DRAFT
MAP Series of PWR Shipping Packages
Amendment to Certificate of Compliance
USA/9319/B(U)F-96
Docket 71-9319

June 9, 2009
Rockville, MD

Revised Licensing Documents

Drawing 9045397 Revision 1

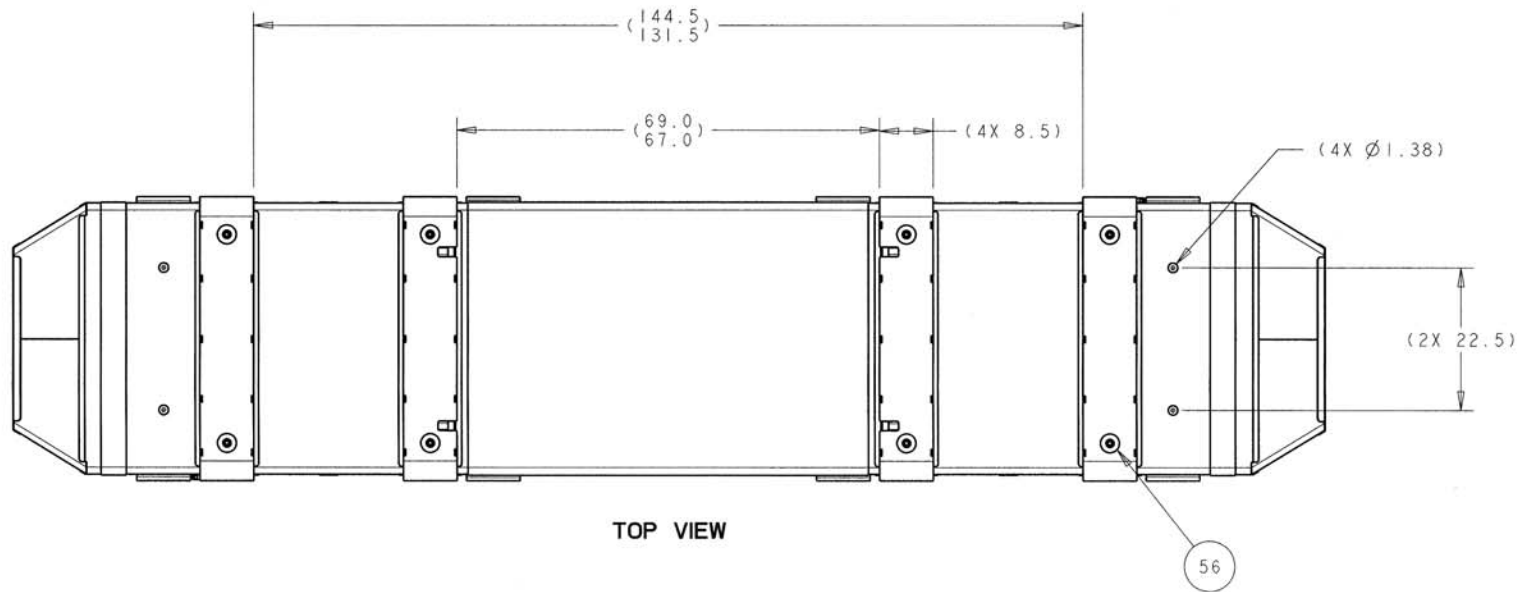
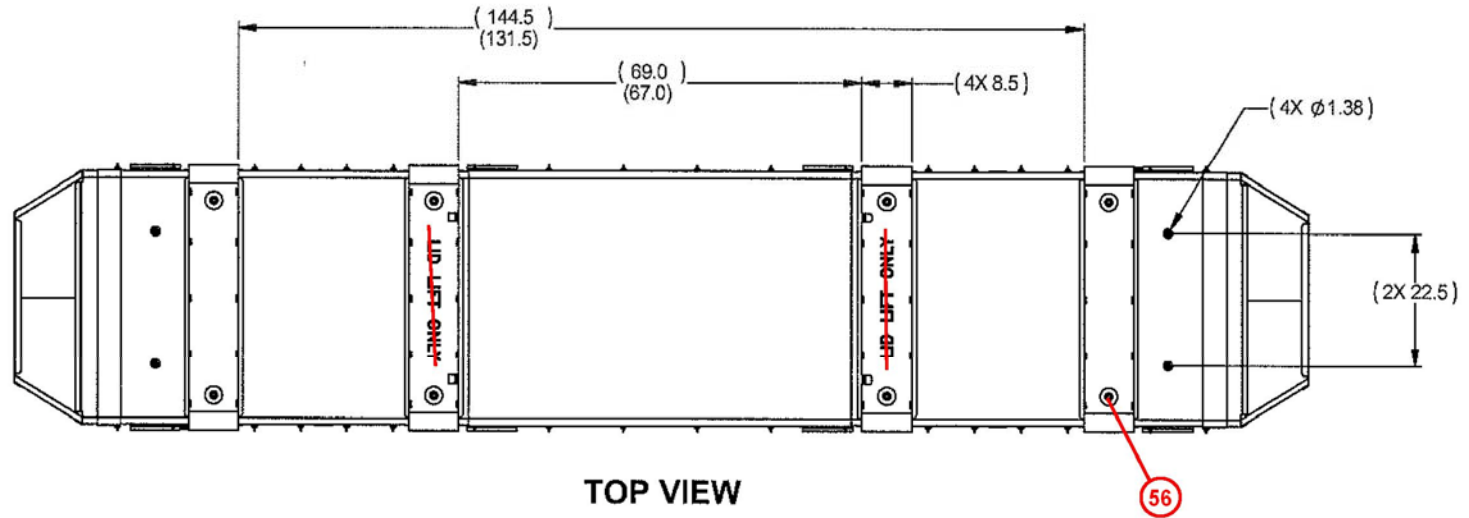
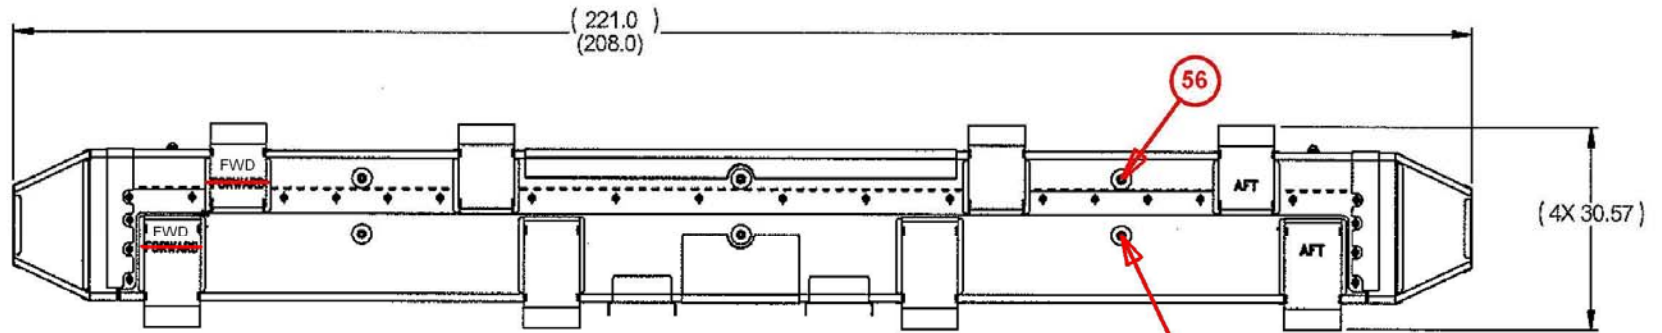
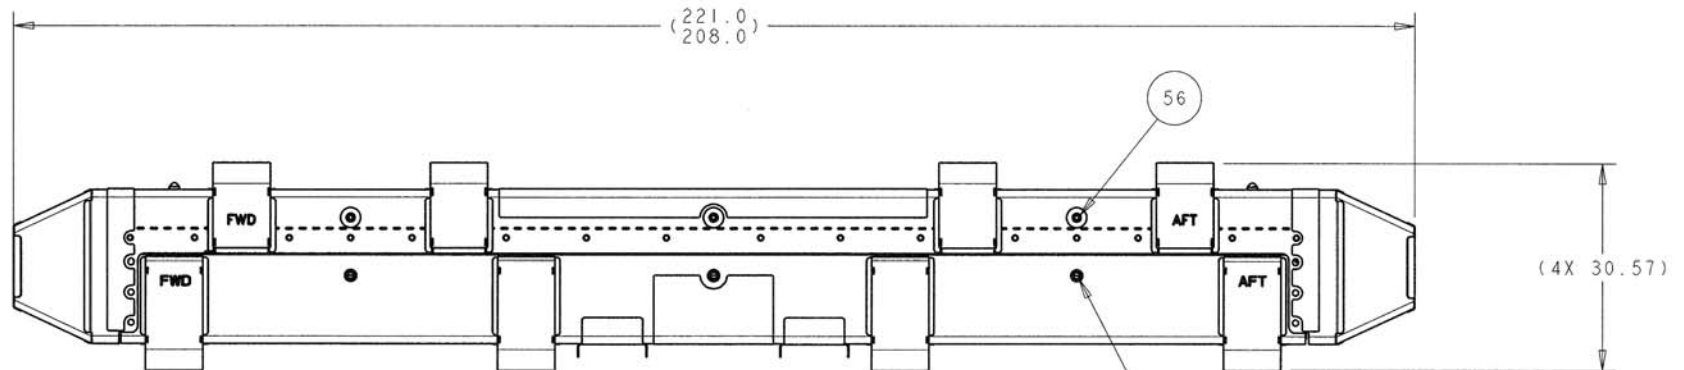
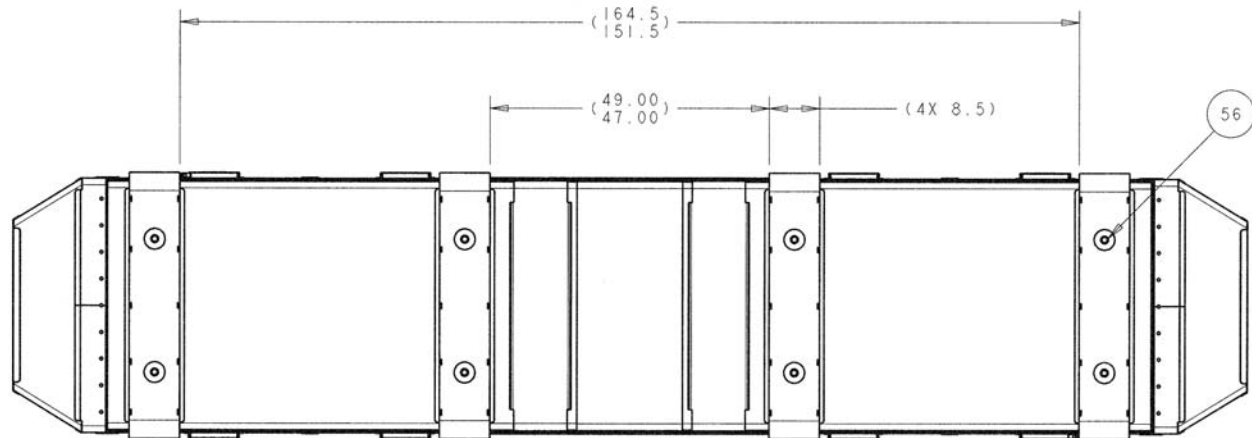
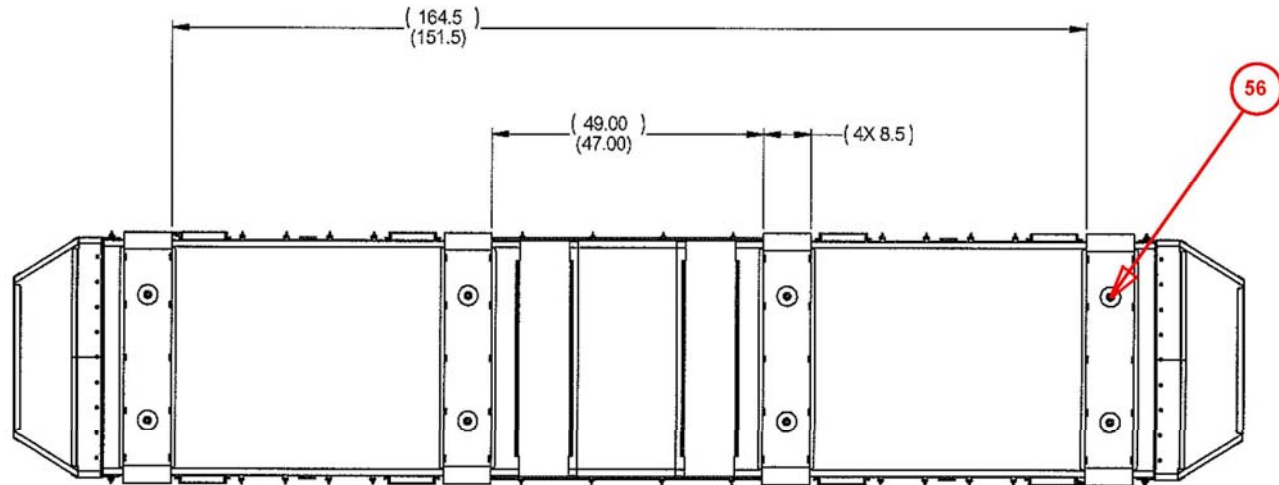
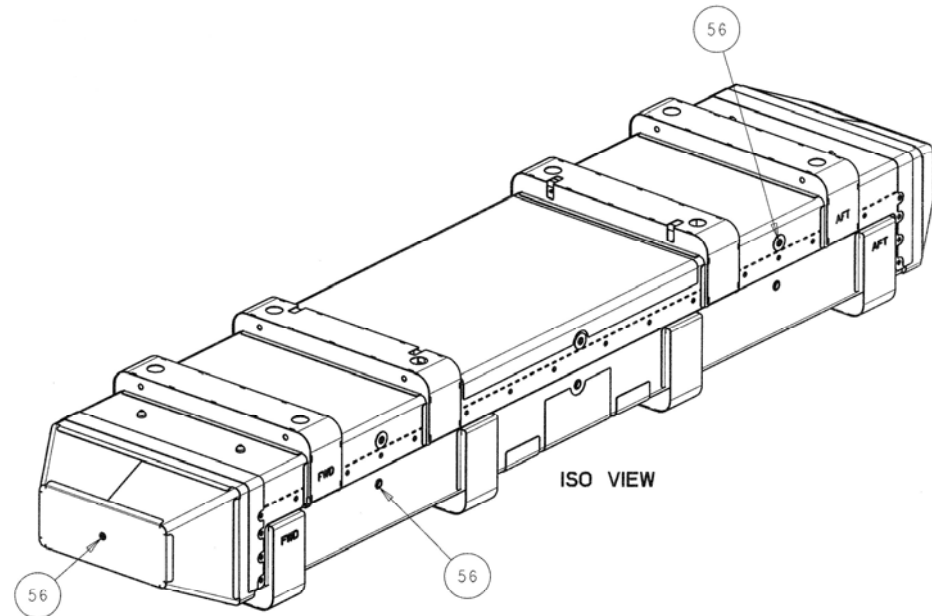
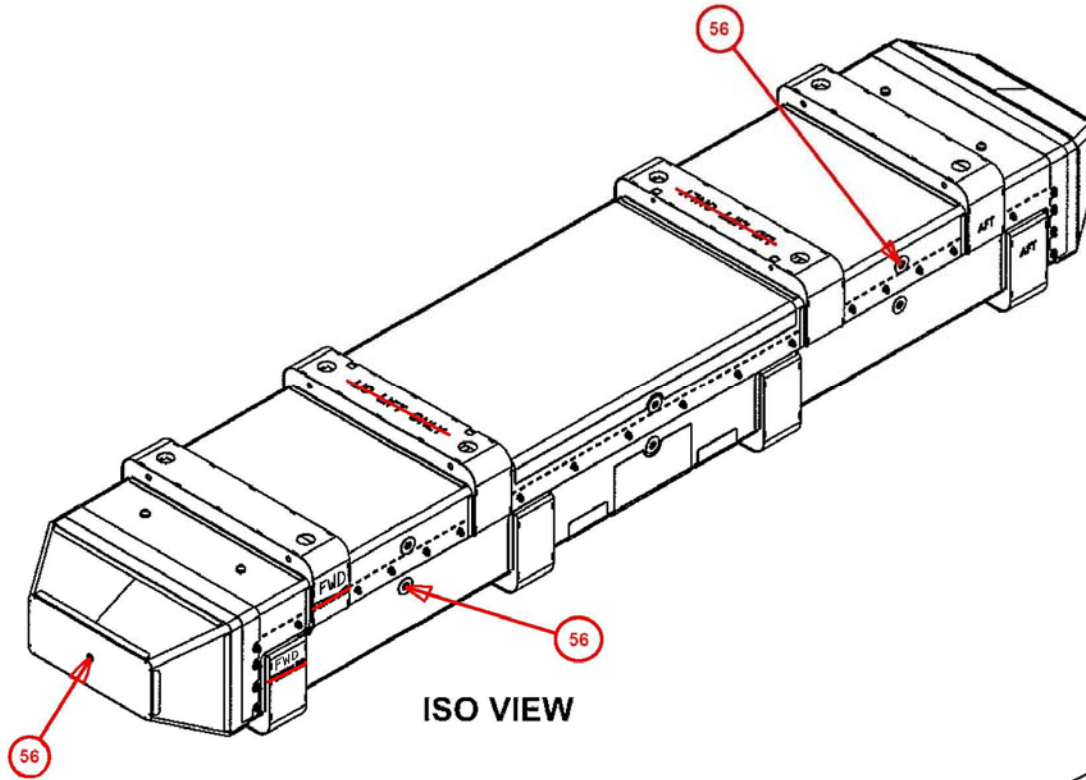
- ◆ ***Recreated in CAD system***
- ◆ ***Added balloons***
- ◆ ***Removed “Lid Lift Only”***
- ◆ ***“FWD” was “FORWARD”***

- ◆ ***Clarification***
- ◆ ***Omitted “Lid Lift Only” to allow use of new lifting fixture on container***

No impact regarding the performance of the container under accident conditions.

Drawing 9045401 Revision 1

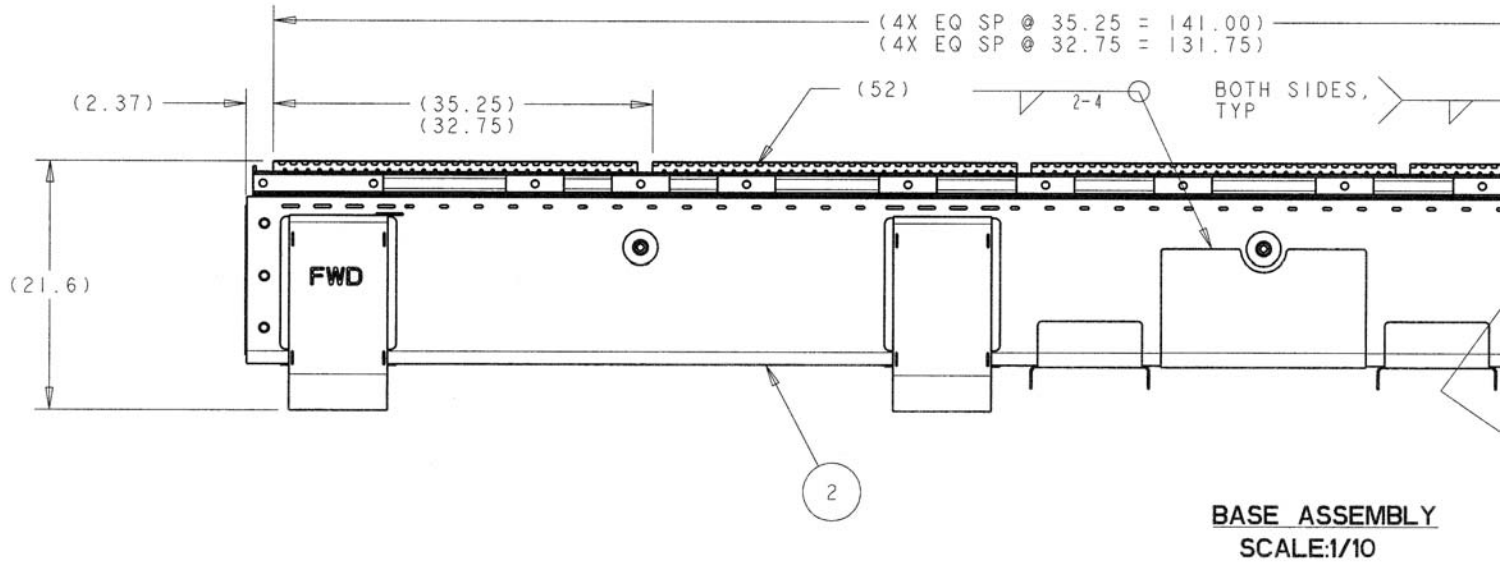
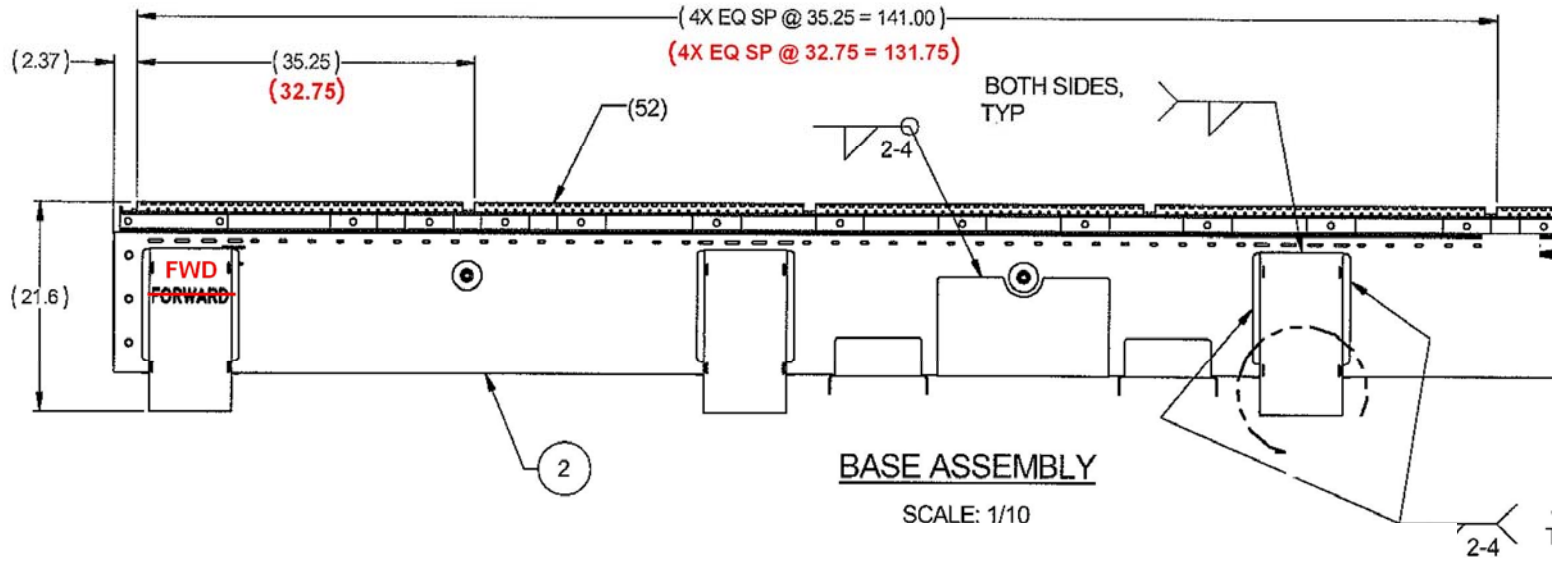
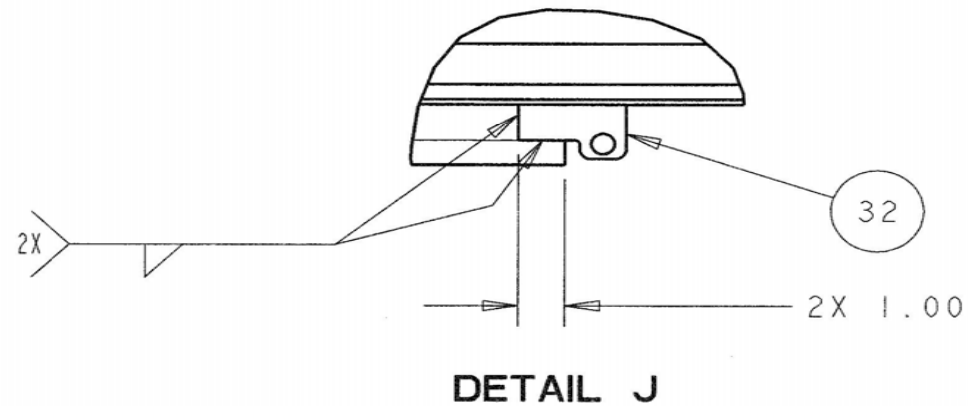
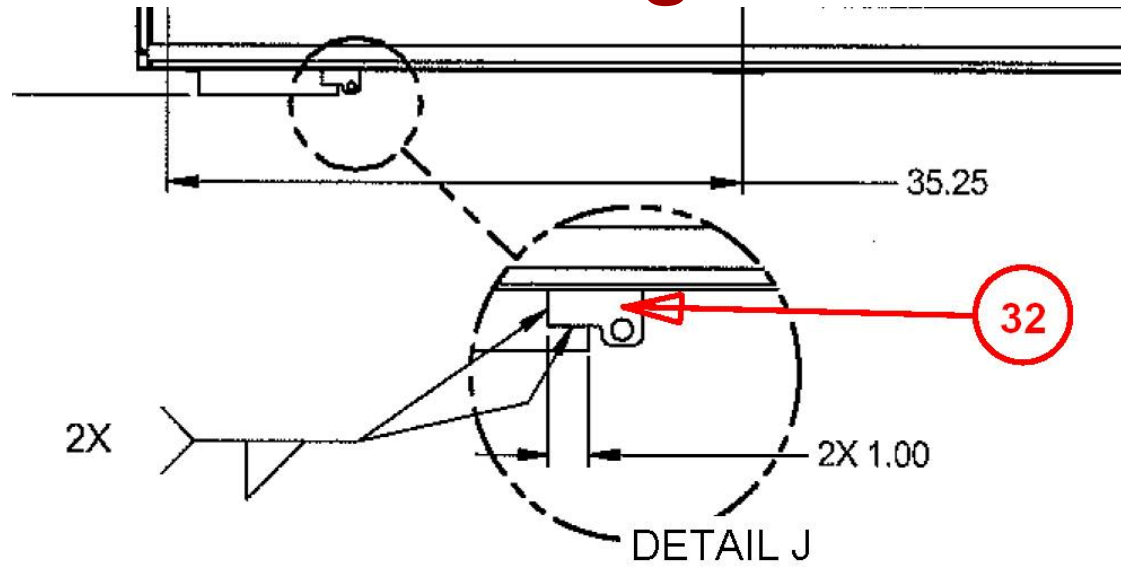
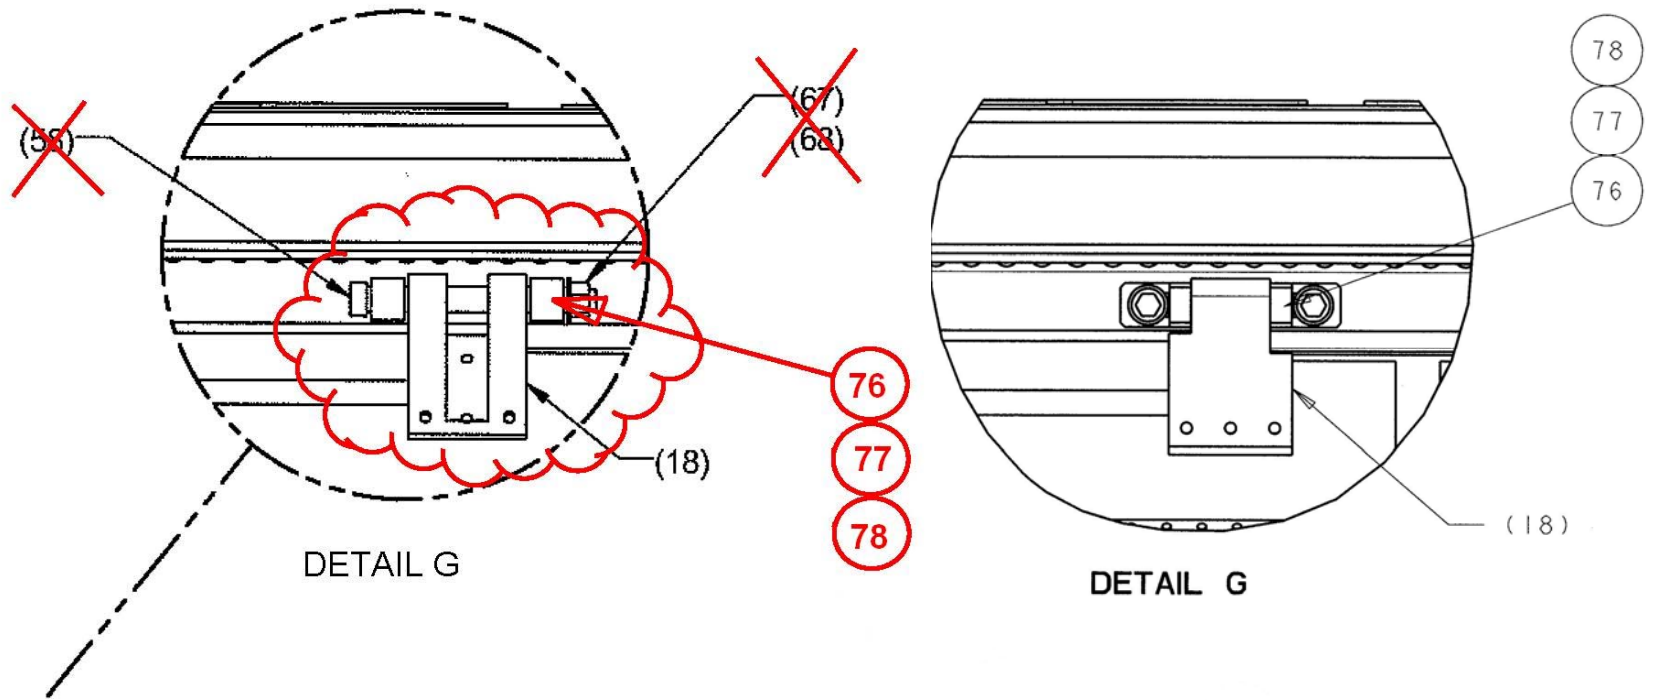
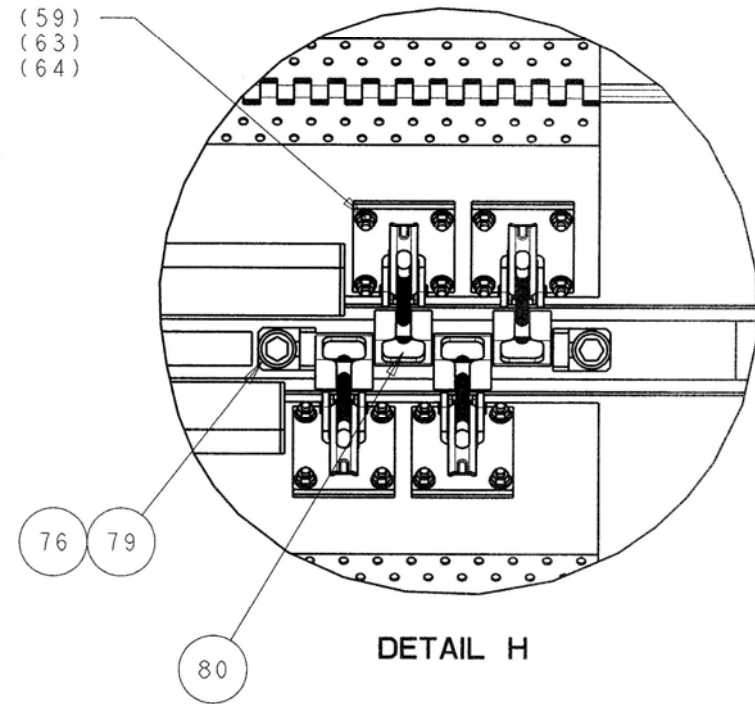
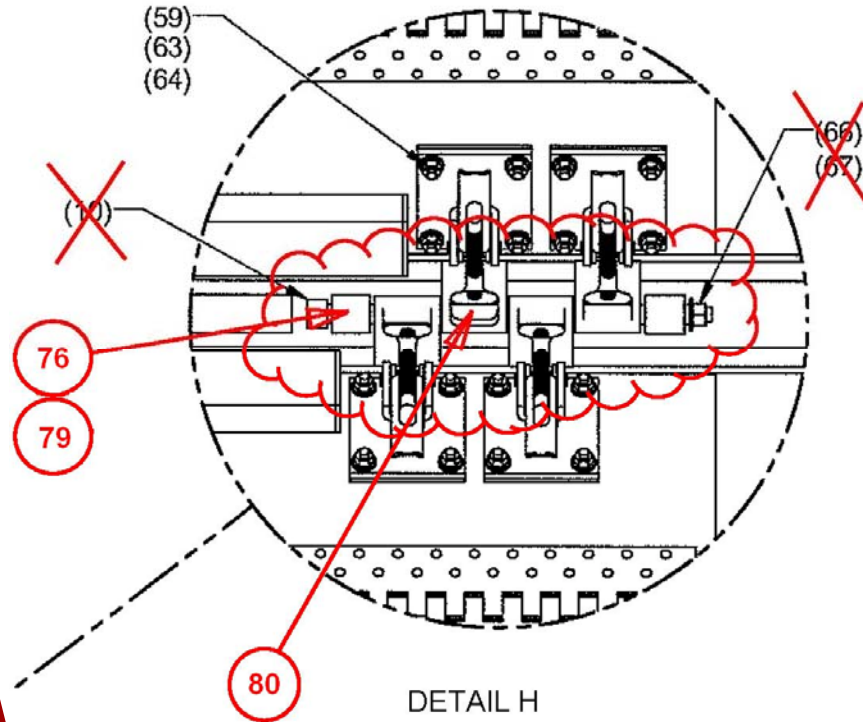
- ◆ ***Recreated in CAD system***
- ◆ ***Updated to reflect current door hinge configuration and applicable items***
- ◆ ***Updated balloons***
- ◆ ***Added lengths to differentiate between MAP-12 and MAP-13***

- ◆ ***Clarification***

No impact regarding the performance of the container under accident conditions.
